**Addendum No. 1**

**Subject:** General Louis Wagner Middle School Culinary Art Suite Renovation  
SDP Contract Nos. B-022C, B-023C, B-024C, B-025C

**Location:** General Louis Wagner Middle School  
1701 W Chelton Ave  
Philadelphia, Pennsylvania 19139

**This Addendum, dated 1 of April, 2021, shall modify and become part of the Contract Documents for the work of this project. Any items not mentioned herein, or affected by, shall be performed strictly in accordance with the original documents.**

DRAWING NO.  
A-100  
SHEET 3 OF 23

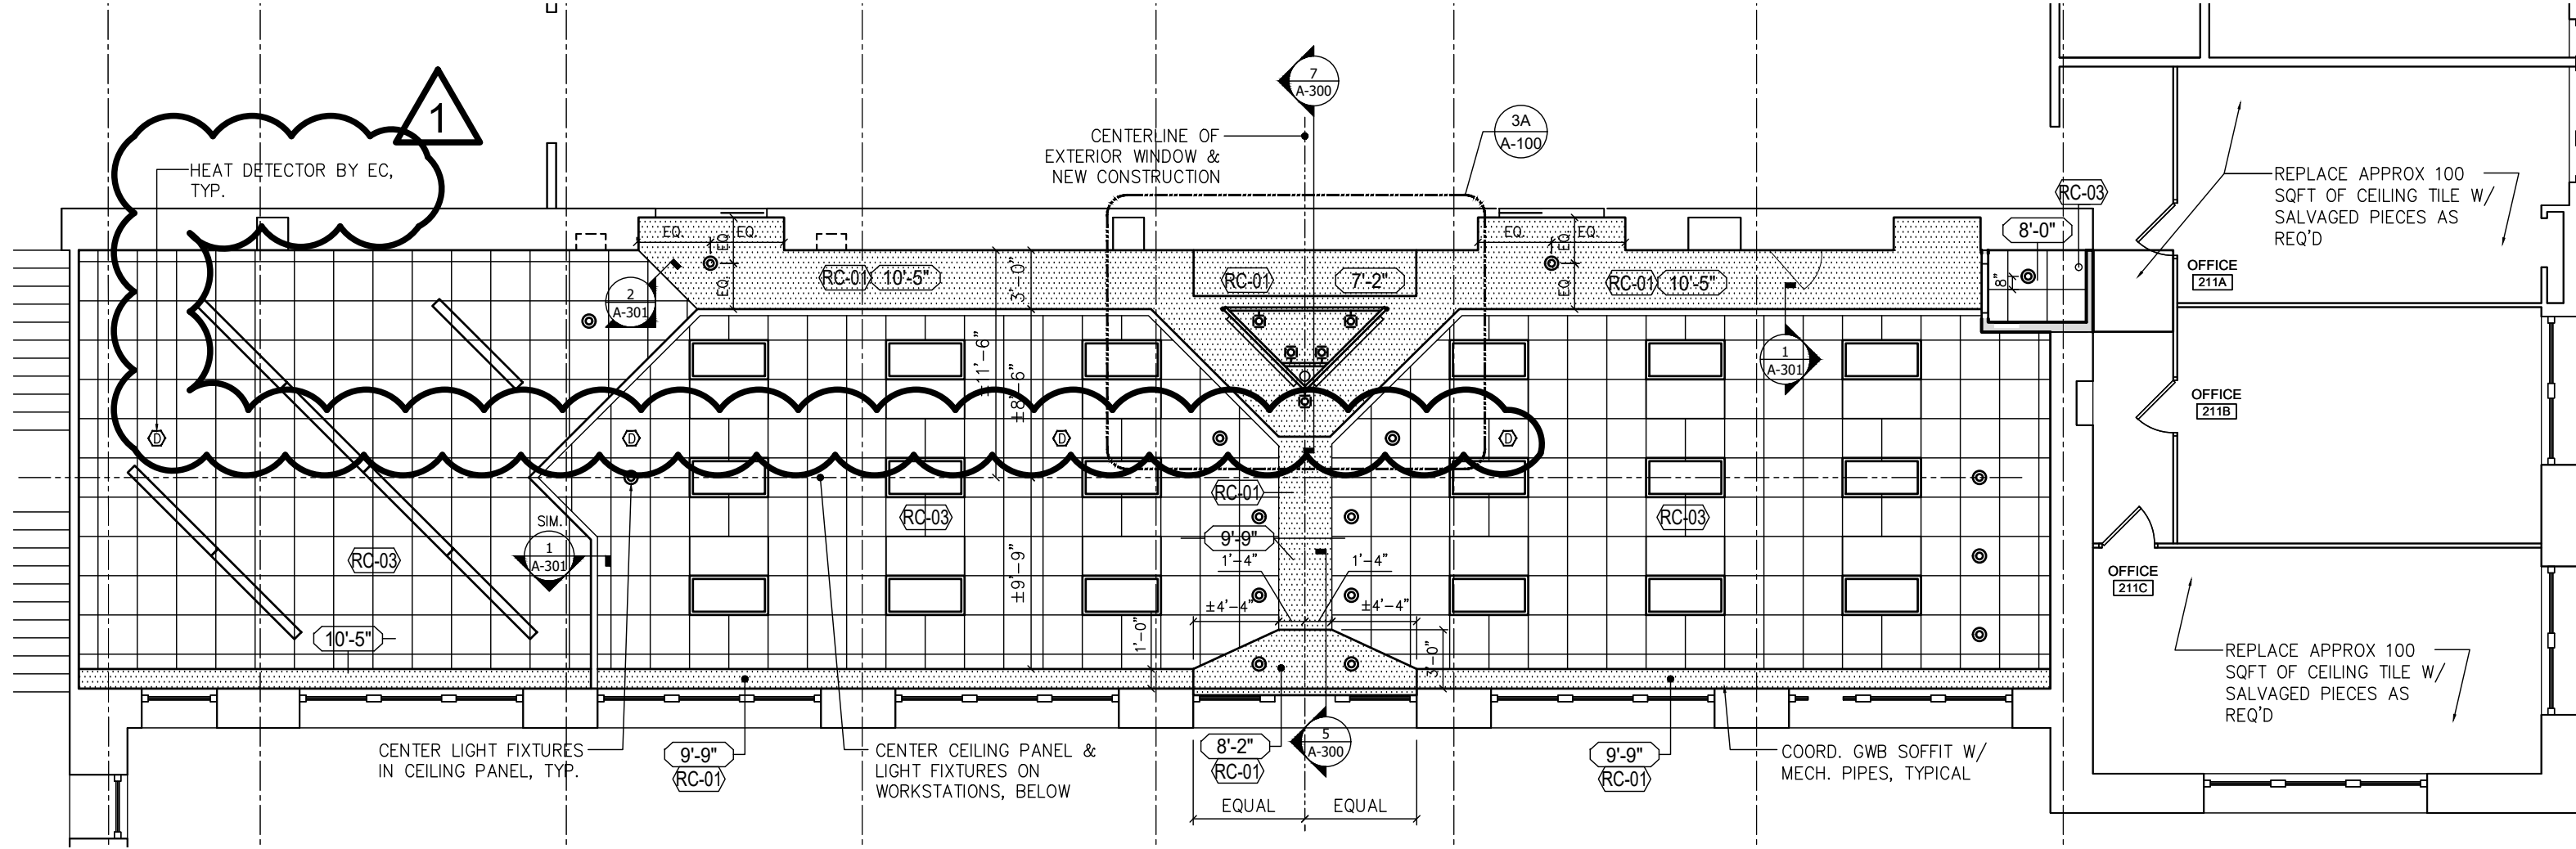
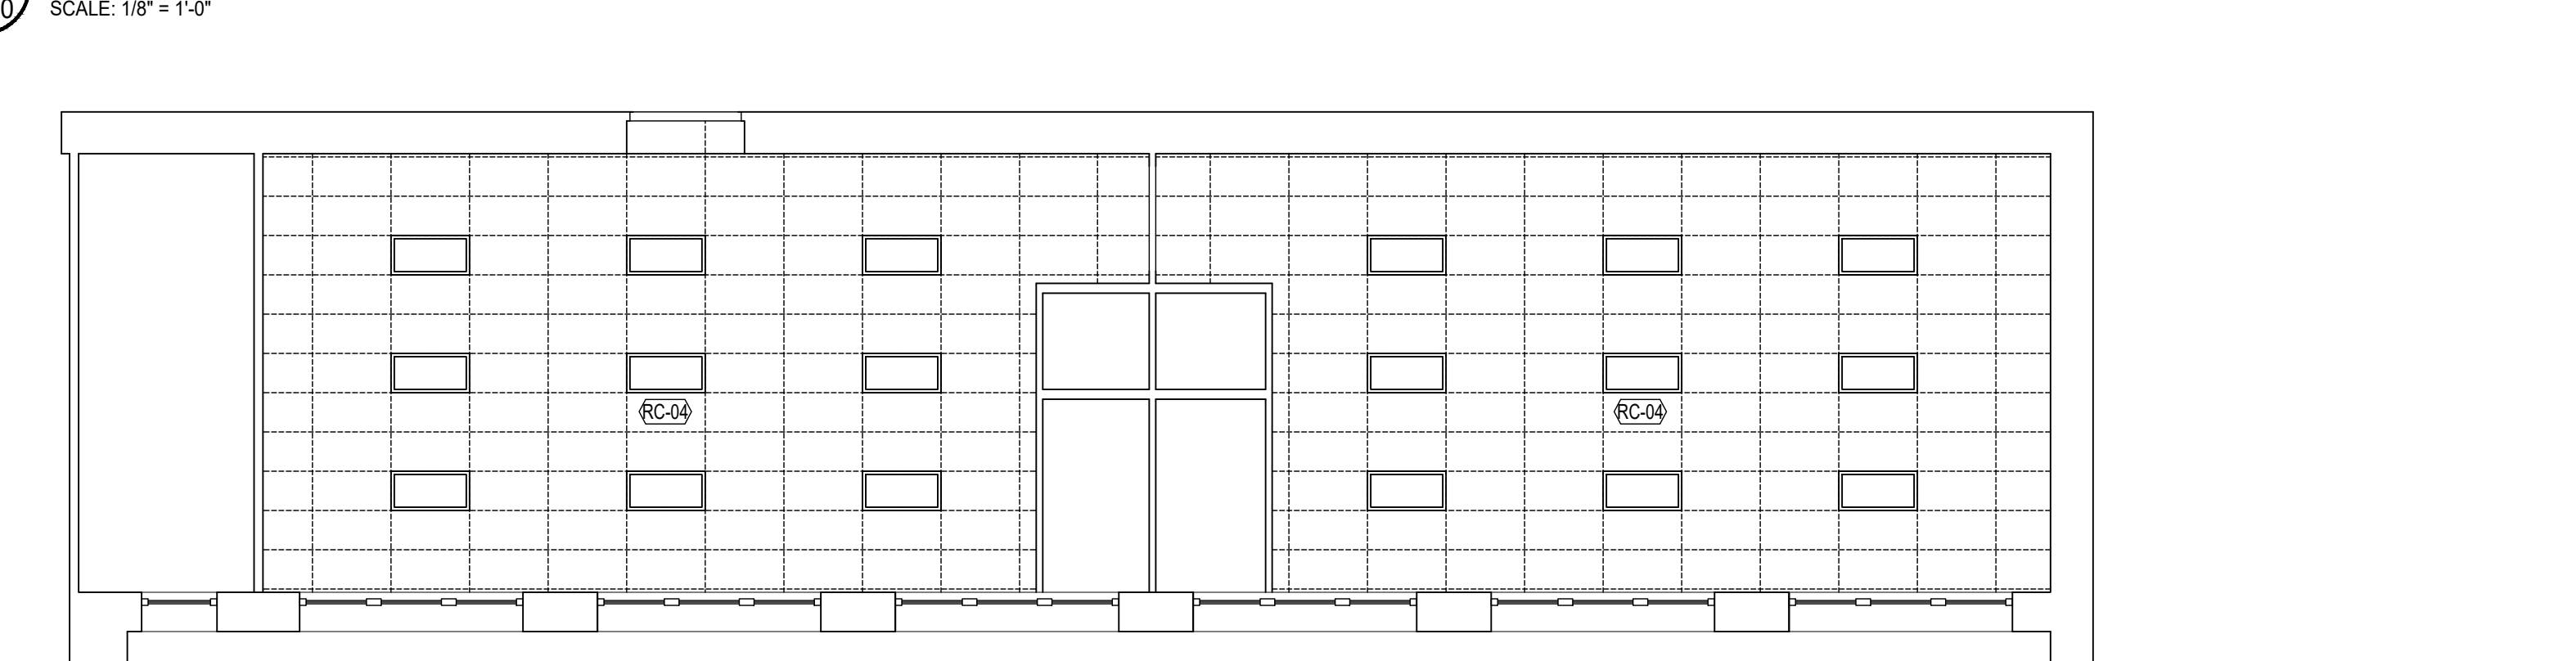
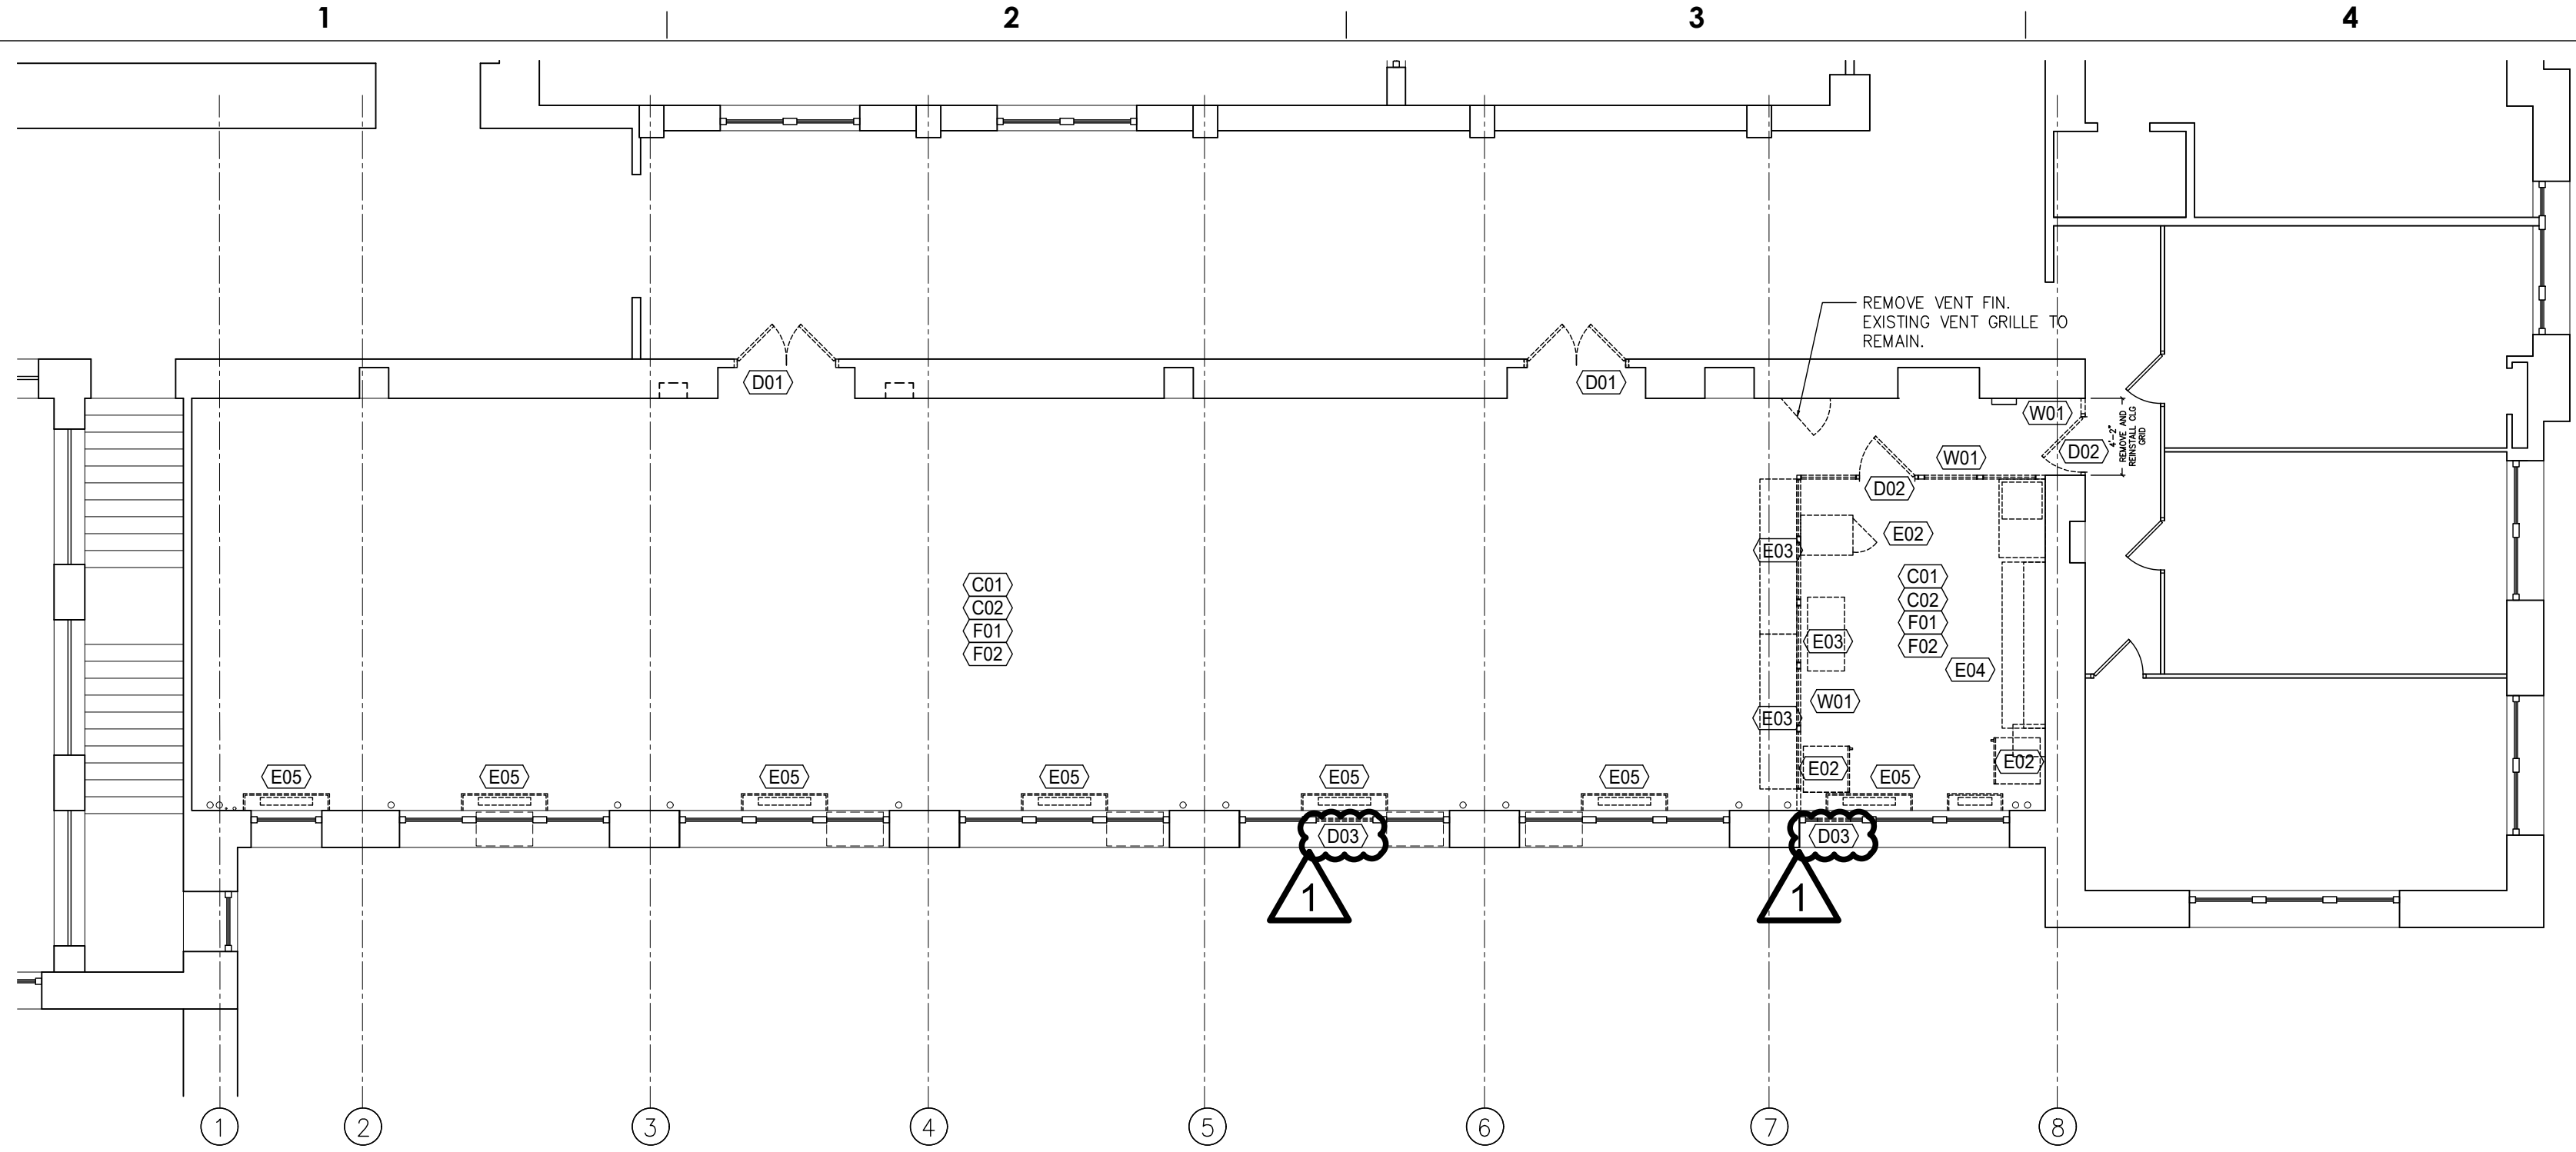
**Drawing: A-100 Demo, New Work, and Ceiling Plans**

- a. Demolition – Keynotes, modify note D03: “Remove portion of metal panel in upper window pane as req’d for new louver / A/C unit. Ref mech dwgs for more info.”
- b. Detail 1/A100-Demolition Plan – Classroom #209, add Demolition Keynotes D03, refer to revised drawings.
- c. Detail 3/A-100-New Reflected Ceiling Plan – Classroom #209, heat detectors added for reference, refer to revised drawings
- d. General Refl. Ceiling Plan Notes, add note #8 “Fire alarm devices / heat detectors shown on architectural RCPs are for reference only and to indicate important alignments. Reference electrical drawings for device types.”
- e. Reflected Ceiling Plan - Keynotes, modify keynotes RC-03 and RC-04 to indicate ceiling types, refer to revised drawings.

Question 10: On Drawing A-100, Detail #4, RC-04 is not referenced on the electrical drawings for the removal and reinstallation of the 1<sup>st</sup> floor lighting fixtures. Should it be or will a 1<sup>st</sup> floor drawing be added for the electrical set of drawings to show that scope of work?

Question 11: On drawing A-100, Detail #3, the ceiling mounted fire alarm devices are not indicated. Will they be added for coordination purposes?

**Answer 10: Existing 1<sup>st</sup> floor lighting fixtures are to remain and be temporarily suspended during work, reference Reflected Ceiling Plan Keynote RC-04 on sheet A-100.**

**Answer 11: Yes, fire devices will be indicated on A-100, Detail #3 for reference only, see Addendum 1.**
